PERMIT

SEWAGE DISPOSAL SYSTEM

SUBDIVISION Country Side ROAD 3559 Countryside Dr. LOT 9

PLOT PLAN

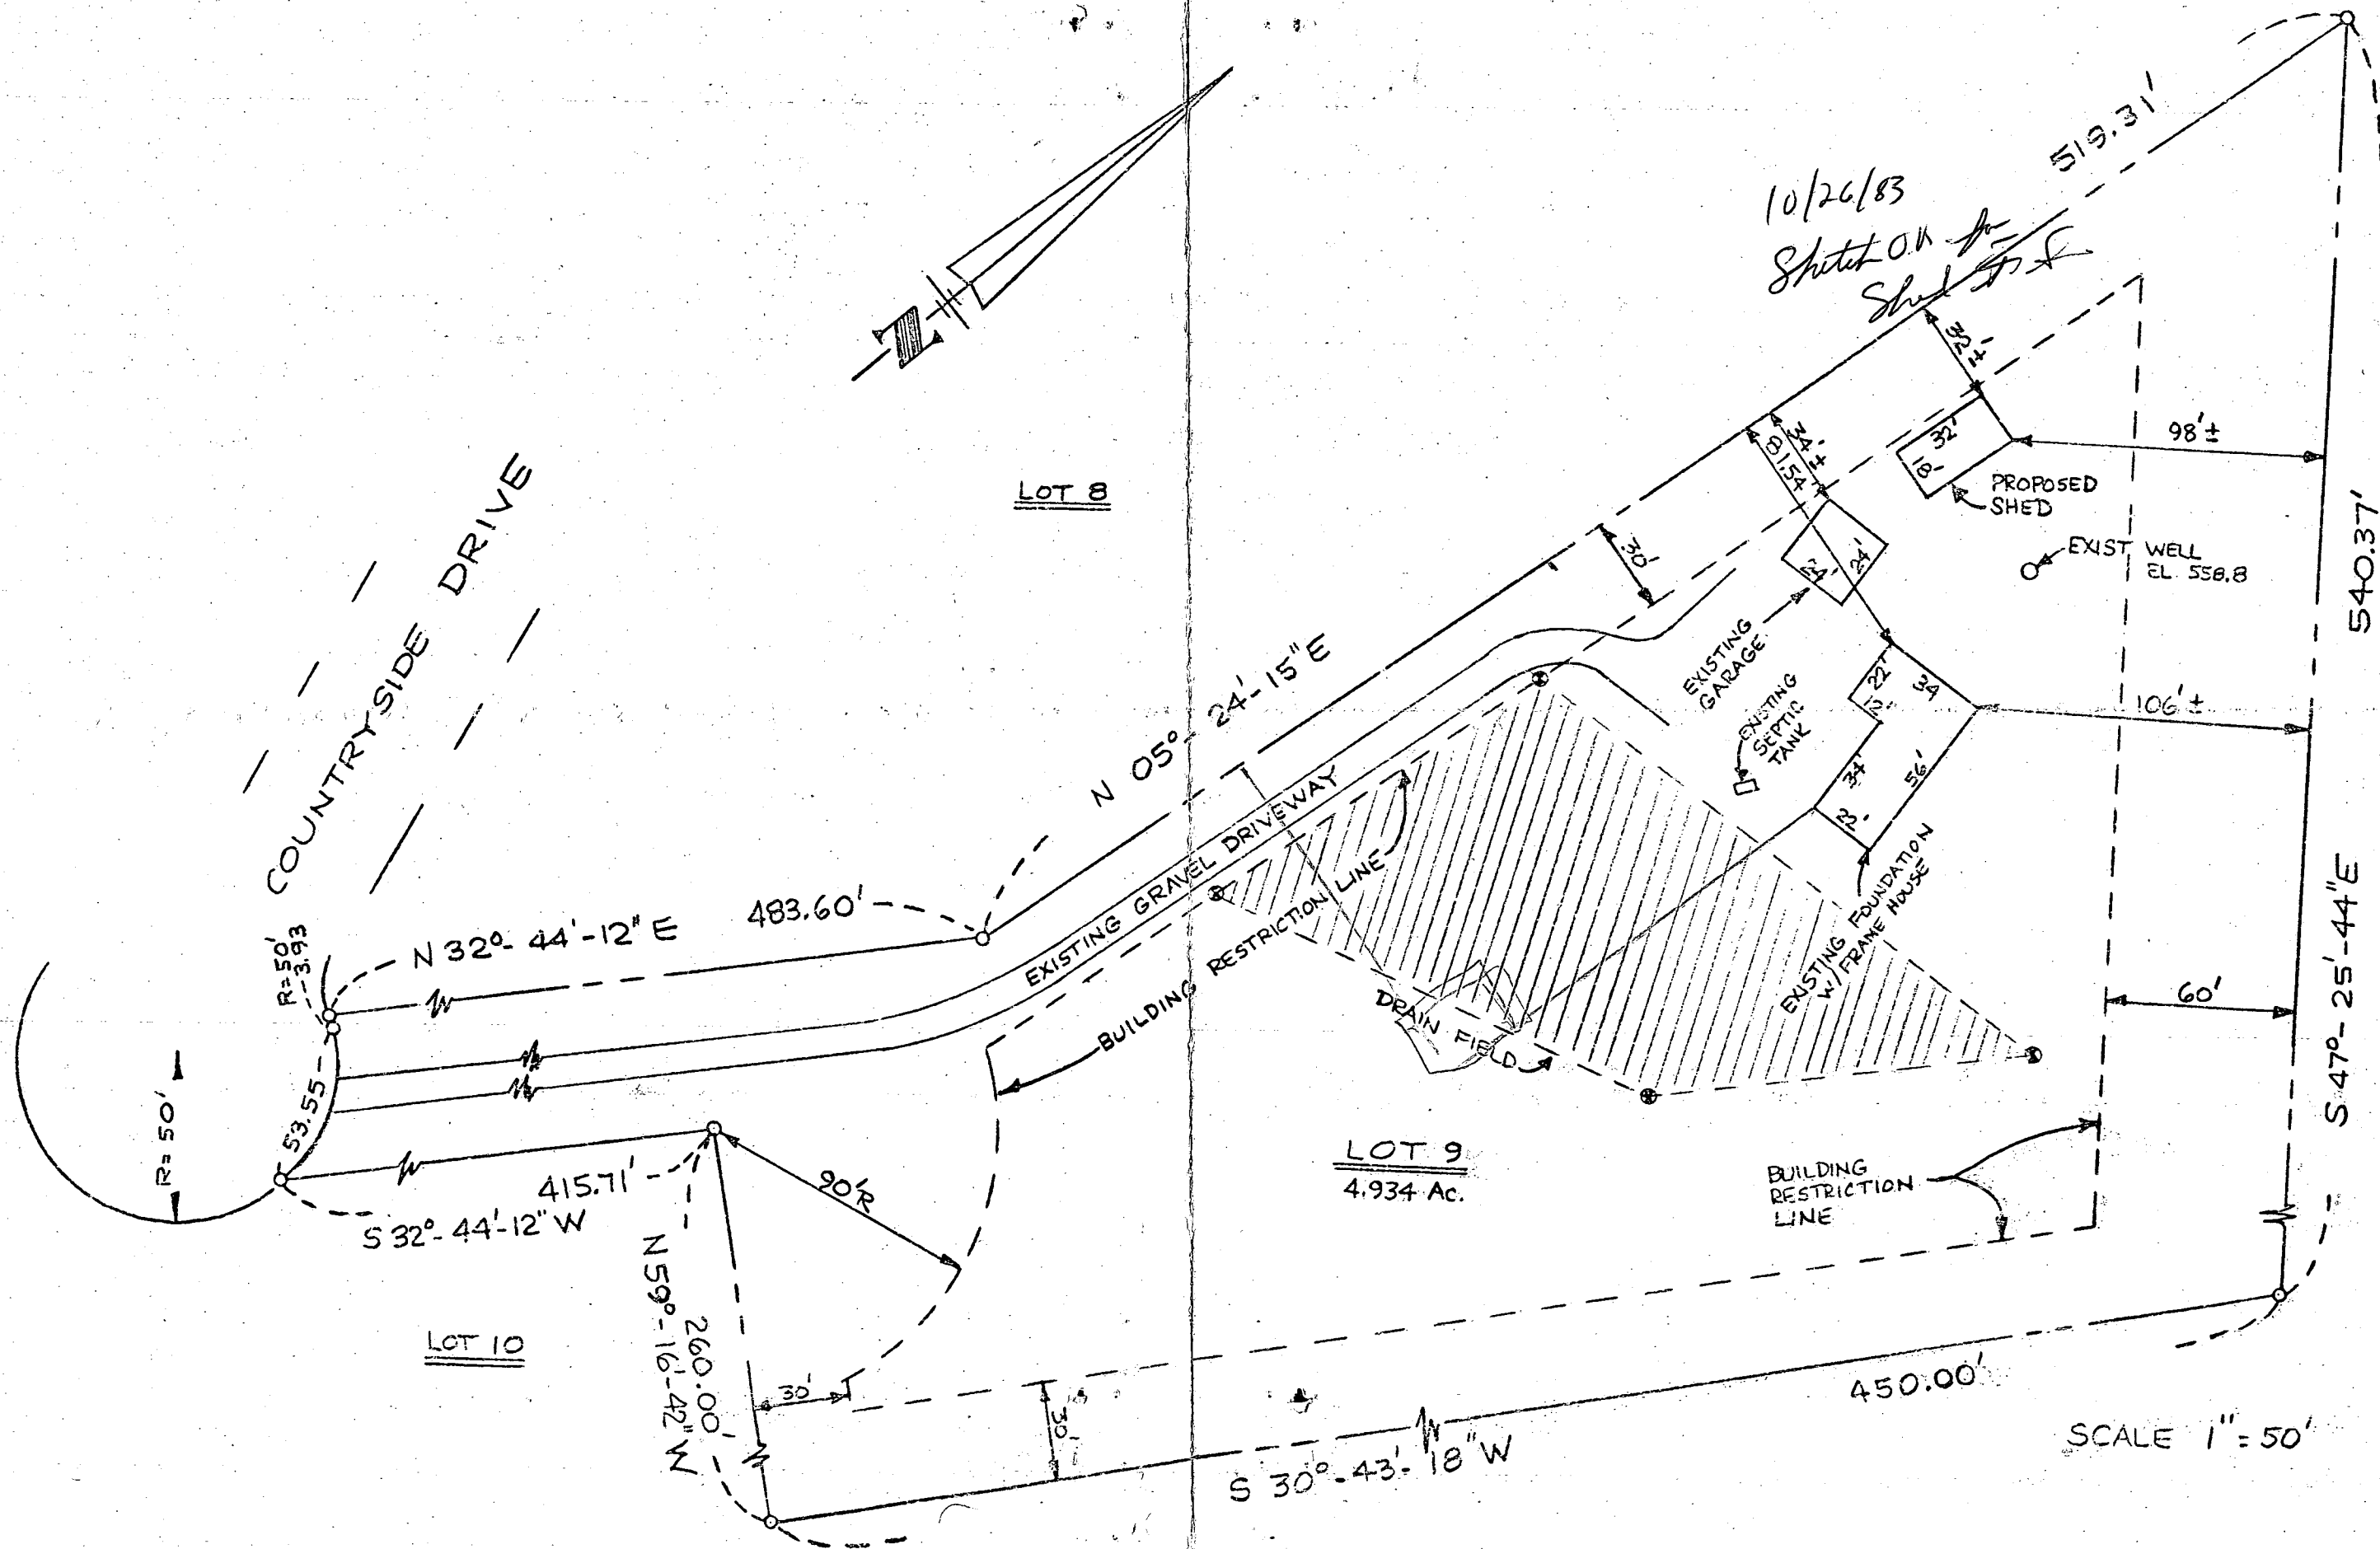
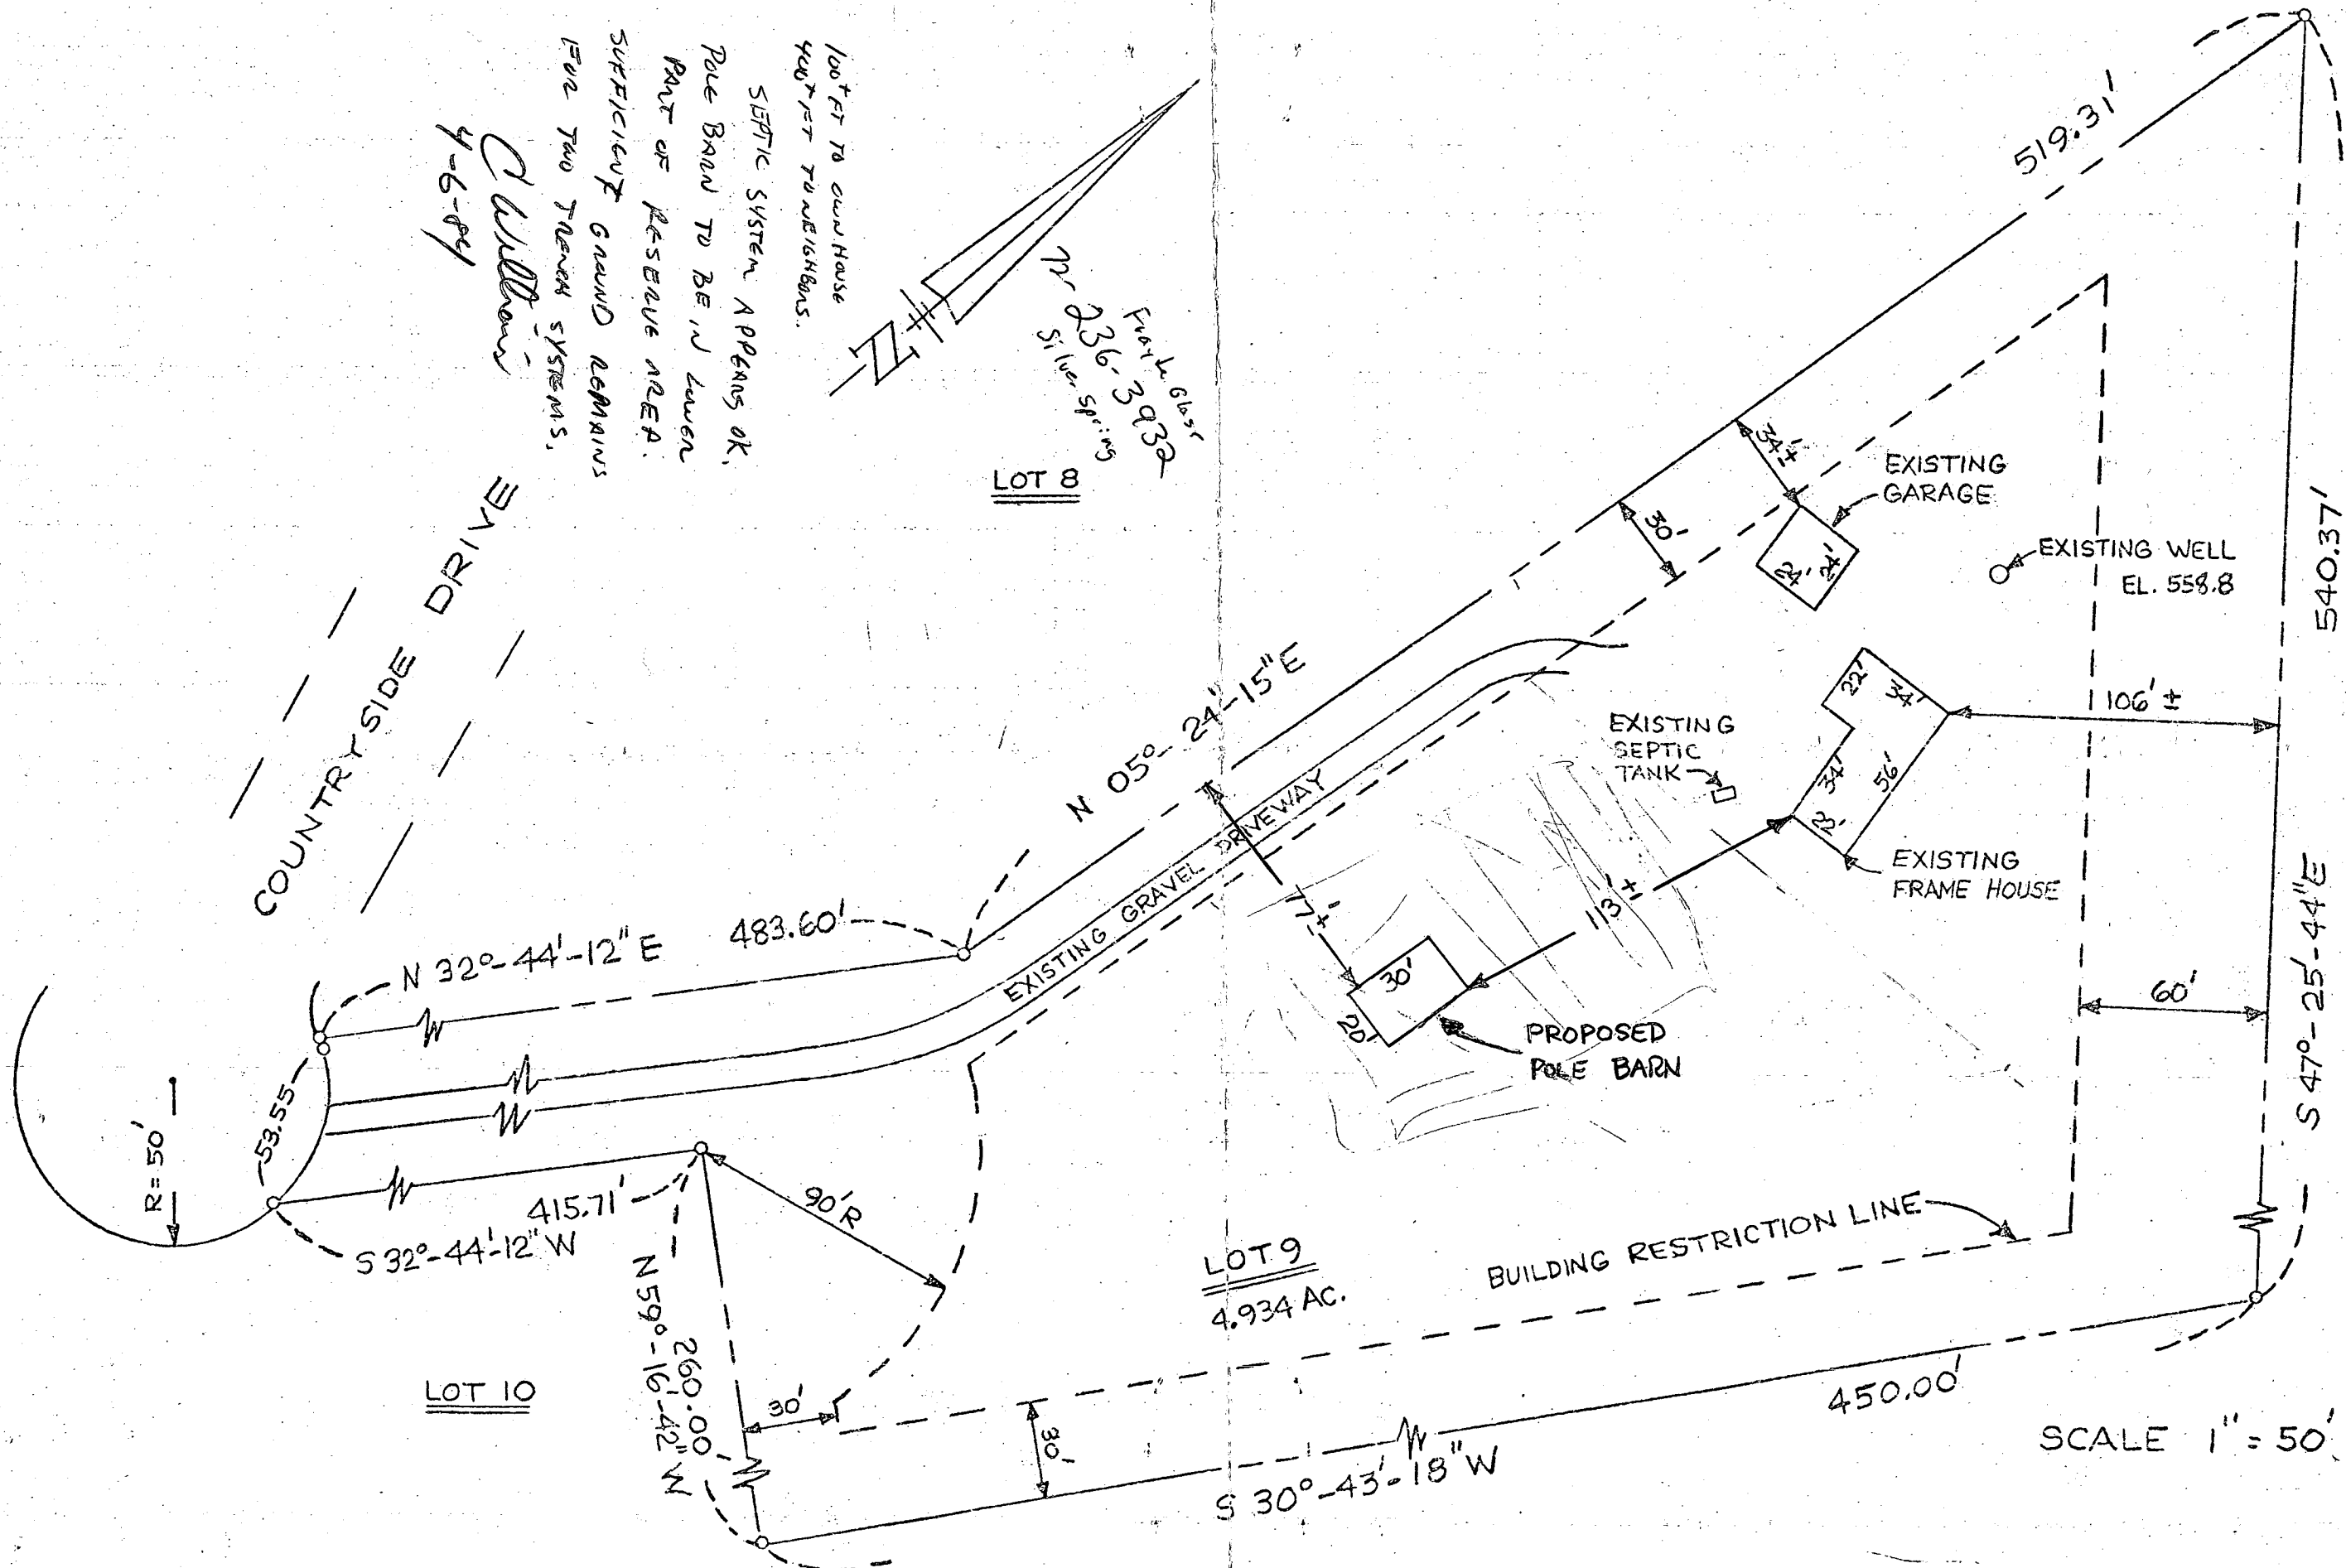
Engineer staked lot 8 - lot 9 lot line shifted
~~and~~ lot 9 $\approx$ 5 Acres

SEPTIC SYSTEM APPEARS OK.
POLE BARN TO BE IN LOWER
PART OF RESERVE AREA.
SUFFICIENT GRASS REMAINS
FOR TWO TRUCK SYSTEMS.

100' FT TO OWN HOUSE
400' FT TO NEIGHBORS.

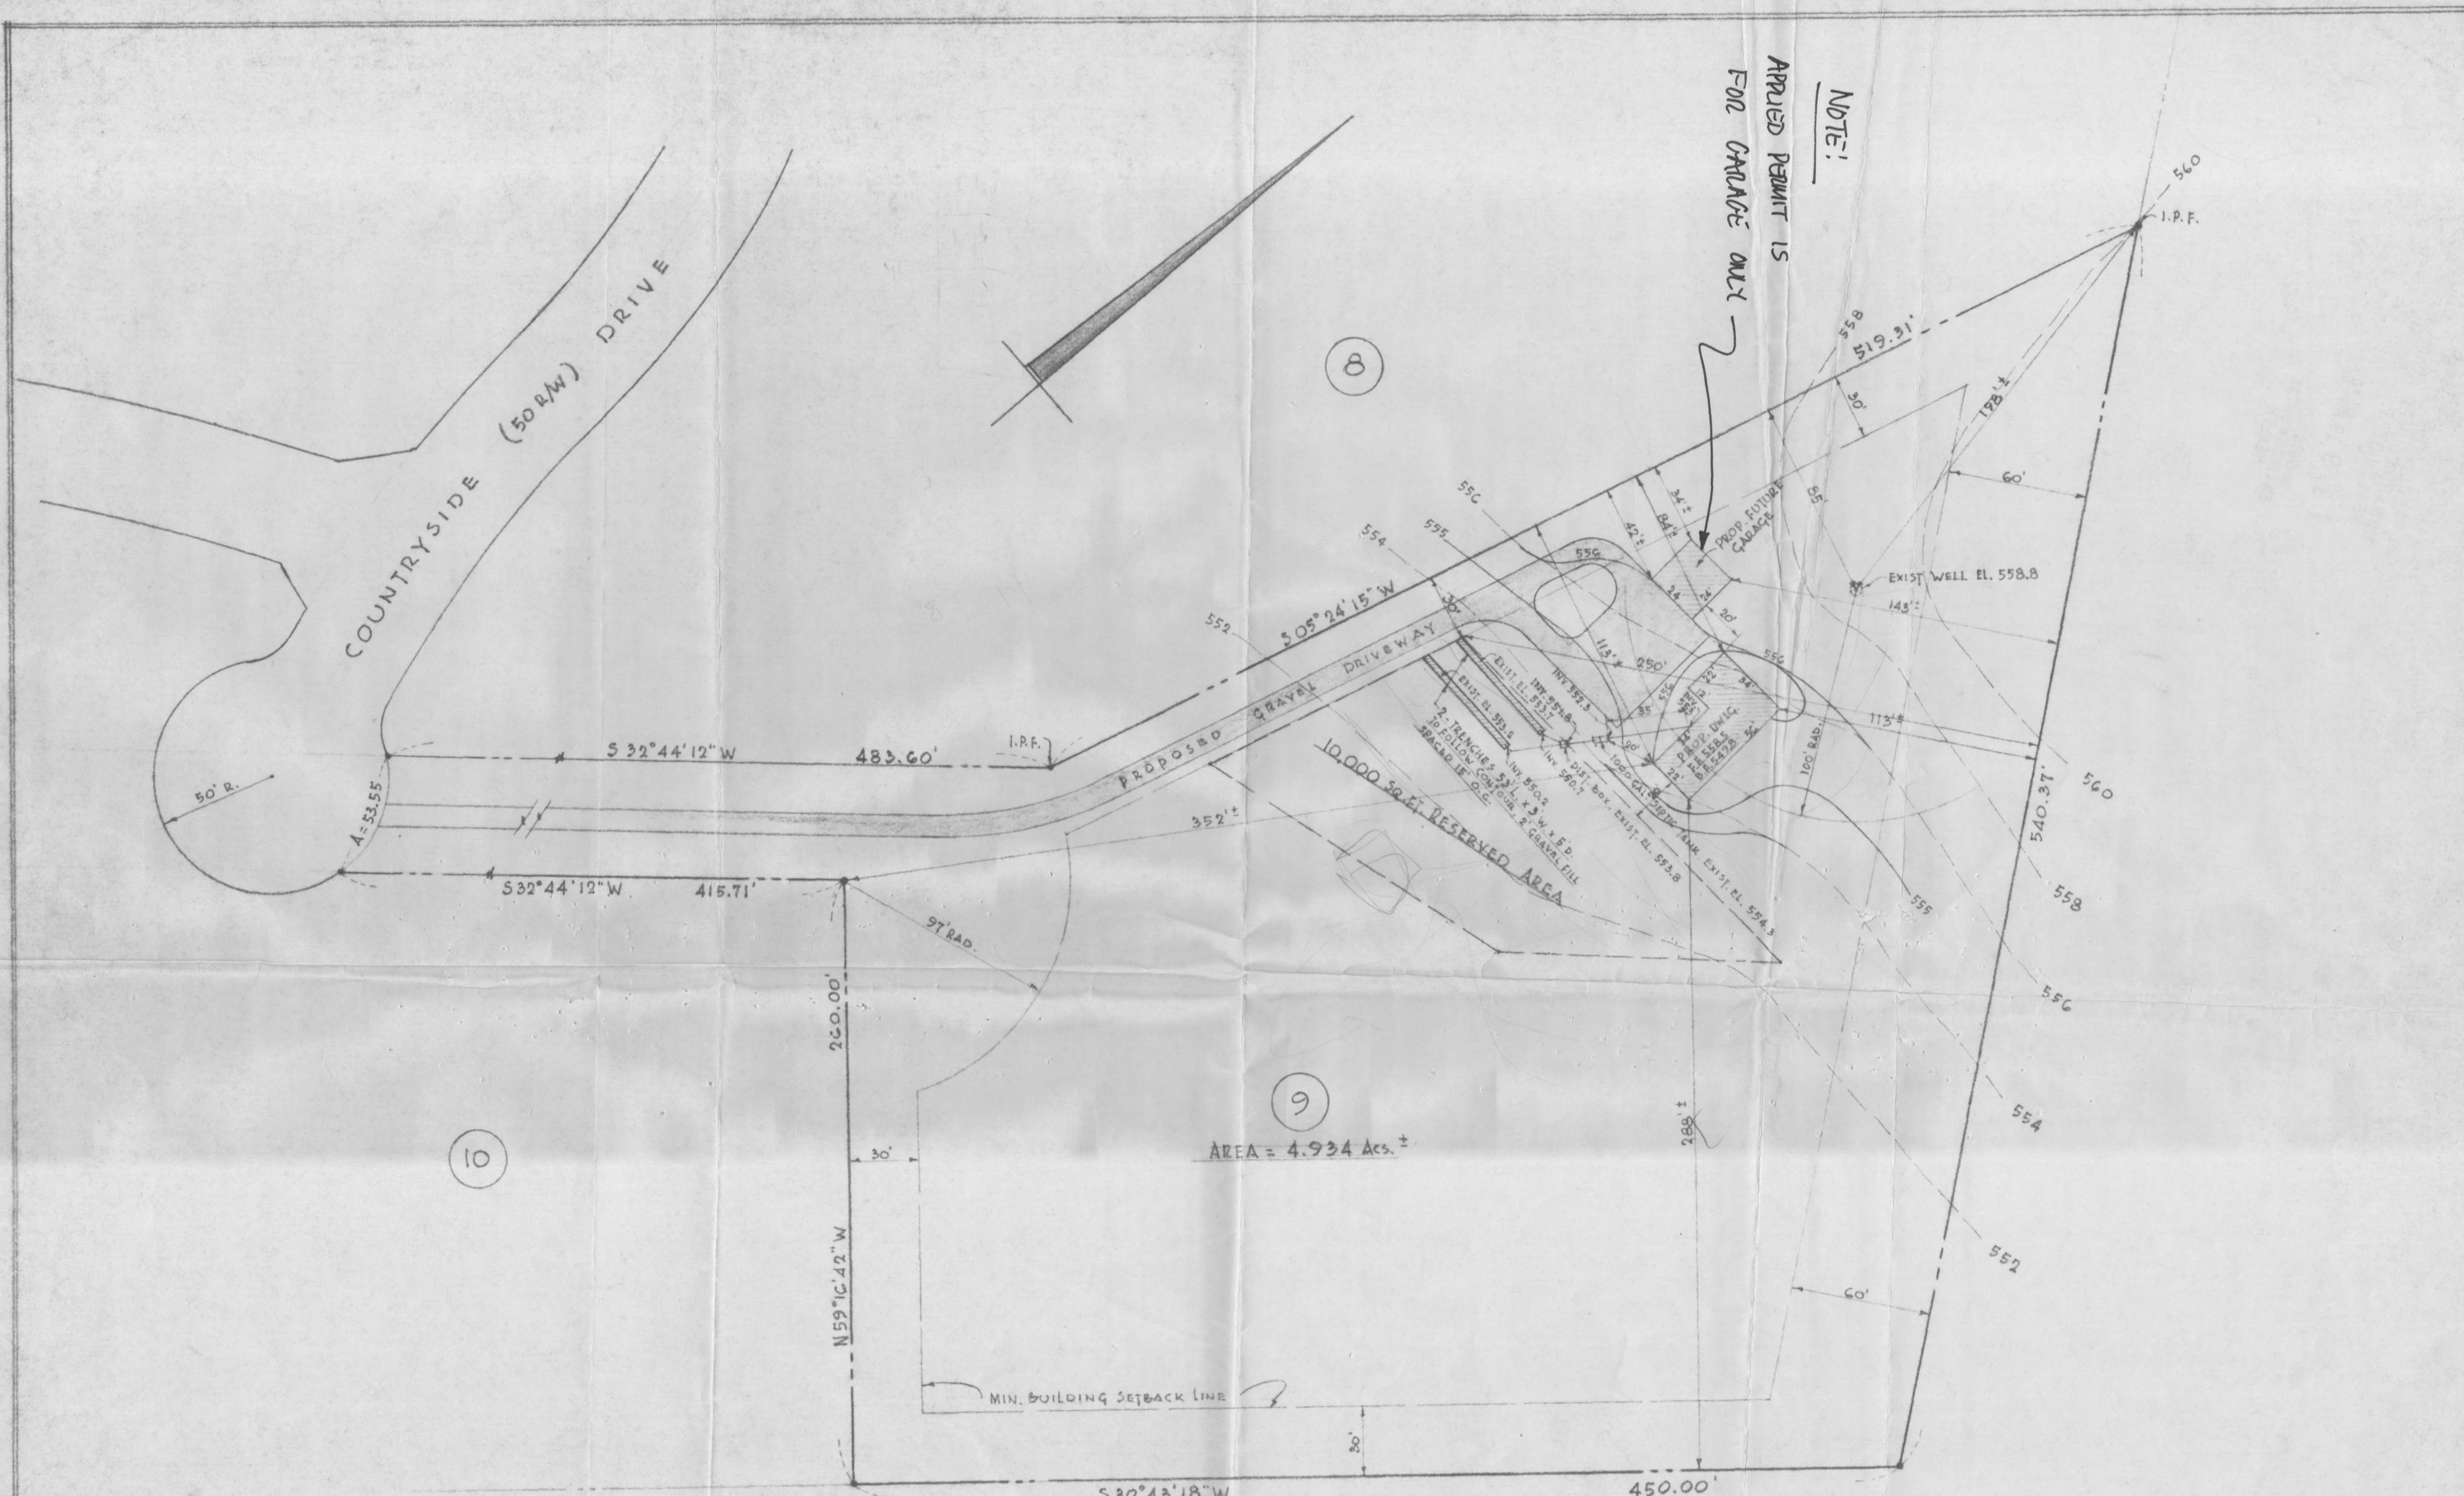
APPROVED PERMIT IS
FOR GARAGE ONLY

6/3/82 Sketch OK for garage
J.S.
